HEDSTROM POULSBO RESIDENCE

COVAL HOMES PLAN - ALDERWOOD

Reviewed for code compliance
with IRC 2015
Kitsap County Building Department
GShapiro@co.kitsap.wa.us
05/20/2020

A201

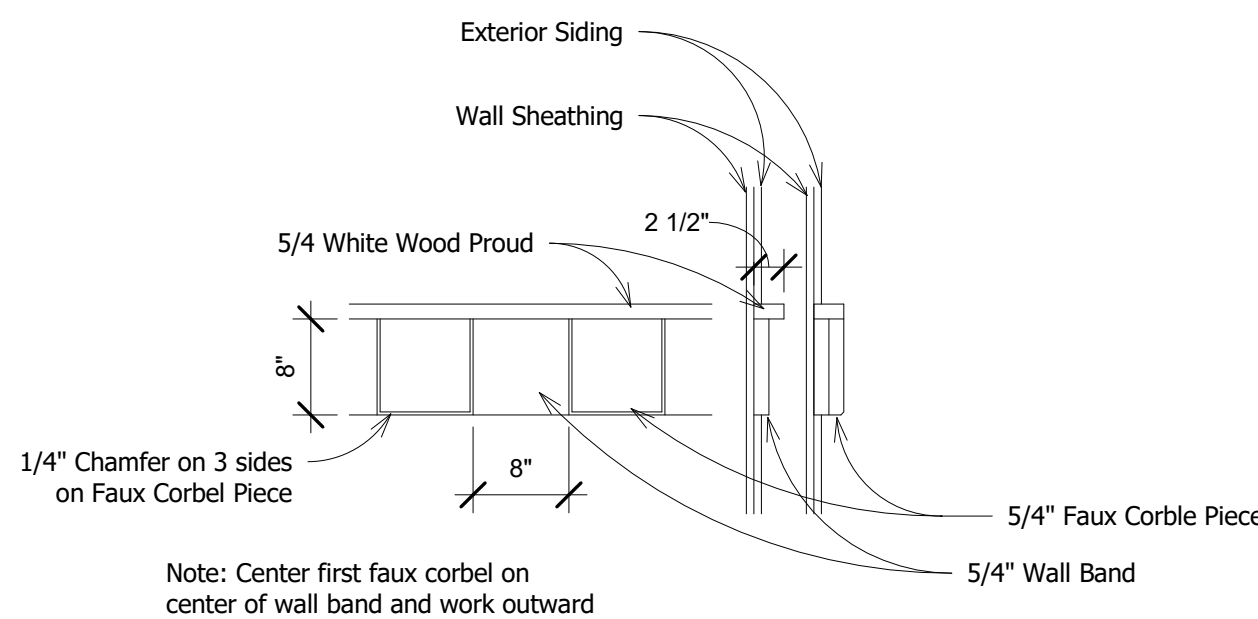
Gutters and downspouts are required.
All roof and yard drains shall be directed to splash blocks at a minimum,
or to an infiltration system if required. All surface drainage shall have a
minimum 2% grade away from the foundation.

Foundation
Plan

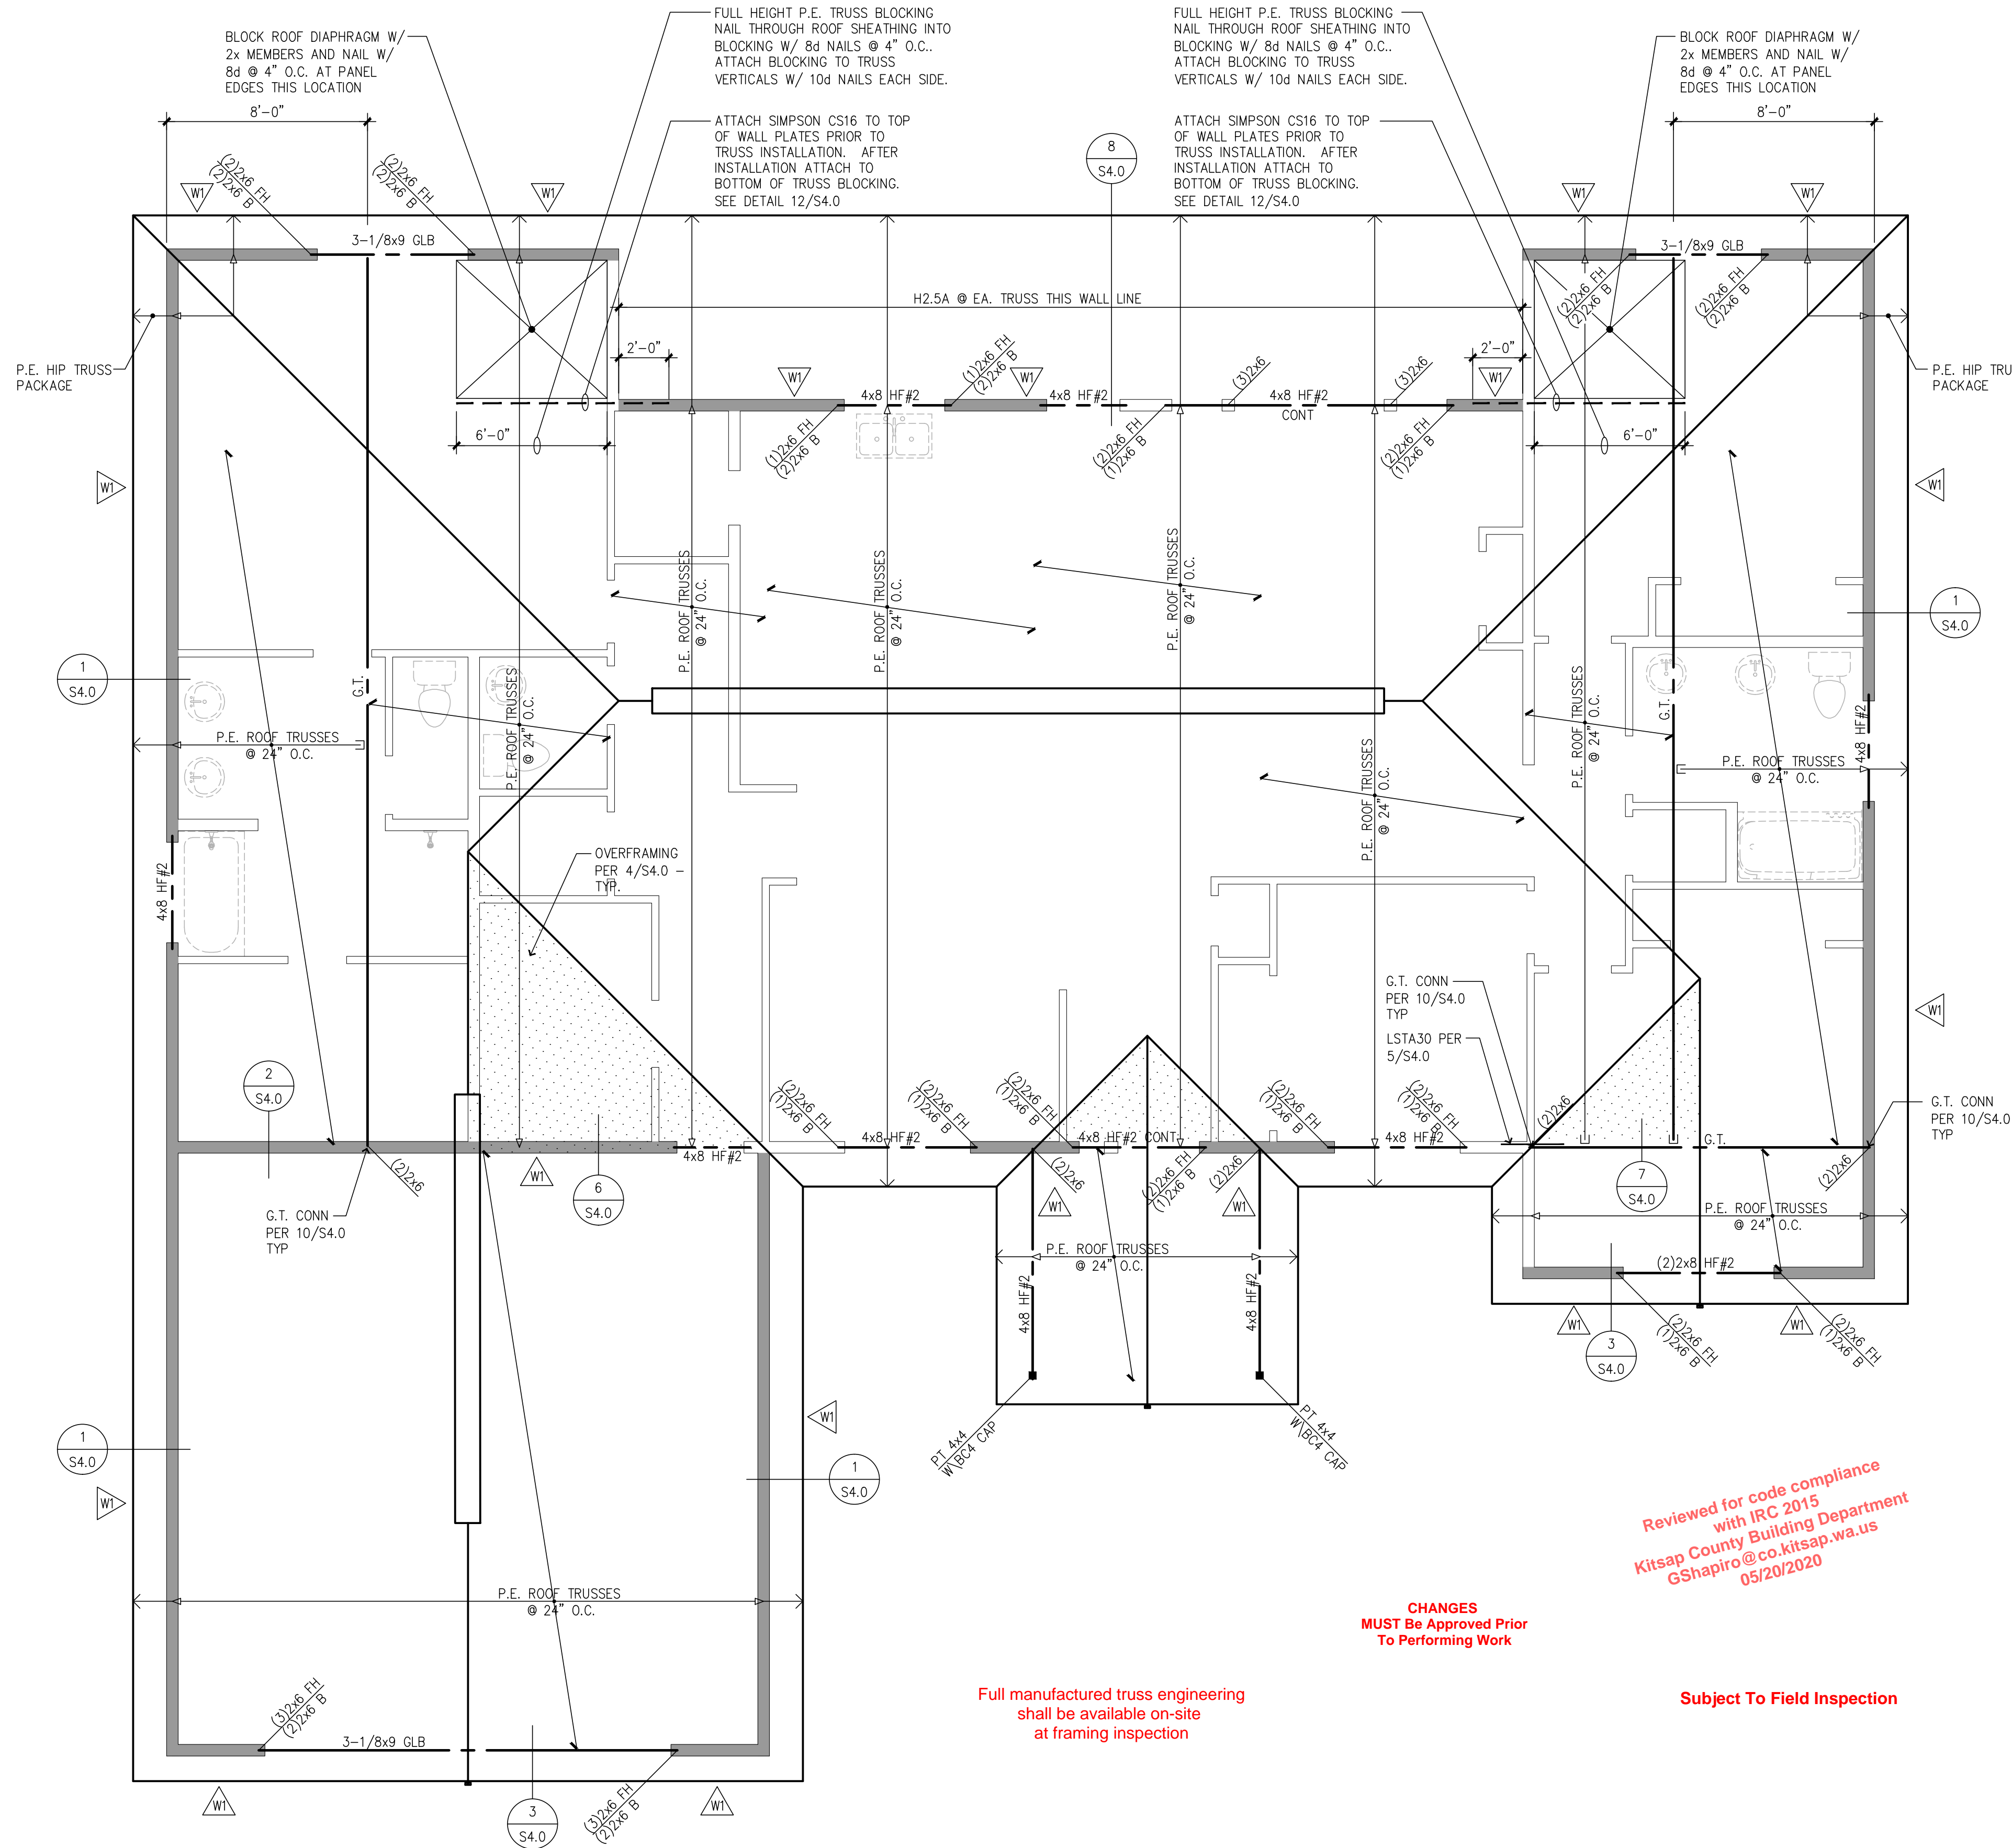
Manufactured joist specs
shall be on-site for inspection
